# United States Patent and Trademark Office

APPLICATION NO.	FILING DATE	FIRST NAMED INVENTOR	ATTORNEY DOCKET NO.	CONFIRMATION NO.
10/815,293	04/01/2004	Matthew Donofrio	5308-390	8325
20792	7590 11/22/2006		EXAM	INER
MYERS BIGEL SIBLEY & SAJOVEC			CHAMBLISS, ALONZO	
PO BOX 37428 RALEIGH, NC 27627			ART UNIT	PAPER NUMBER
KALEIOH, N	C 27027		2814	·

Application No.	Applicant(s)			
Office Action Commence	10/815,293	DONOFRIO, MATTHEW			
Office Action Summary	Examiner	Art Unit			
	Alonzo Chambliss	2814			
The MAILING DATE of this communication app Period for Reply	ears on the cover sheet with the c	orrespondence address			
A SHORTENED STATUTORY PERIOD FOR REPLY IS SET TO EXPIRE 3 MONTH(S) OR THIRTY (30) DAYS, WHICHEVER IS LONGER, FROM THE MAILING DATE OF THIS COMMUNICATION.  - Extensions of time may be available under the provisions of 37 CFR 1.136(a). In no event, however, may a reply be timely filed after SIX (6) MONTHS from the mailing date of this communication.  - If NO period for reply is specified above, the maximum statutory period will apply and will expire SIX (6) MONTHS from the mailing date of this communication.  - Failure to reply within the set or extended period for repl

Figure 10

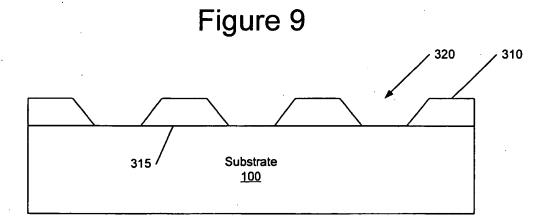
Not approved
